SUBMISSION: 19-23 Rosalind Street, Cammeray.

Please accept this document as objection to the proposed SSD (SSD-96505456) based on the following criteria which will be discussed in further detail in this submission:

Figure 1

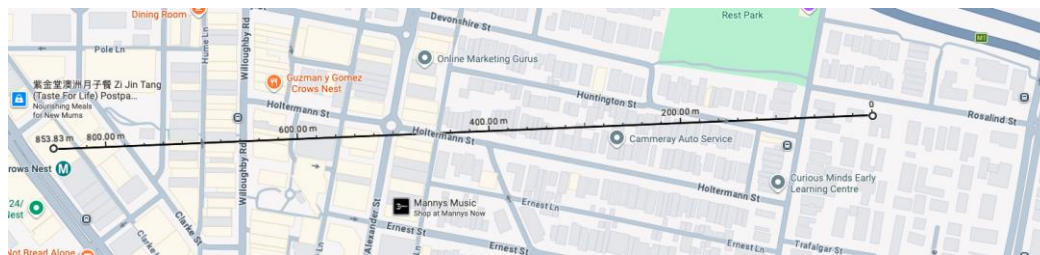
In the EIS, Section 2.1 Site and Location of the EIS states that,

“Crows Nest Station is located approximately 800 metres north-west of the site.”

Please refer to figure 1 below taken from Google Maps and using their distance program, the distance from the proposed site to Crows Nest station is greater than 850 metres
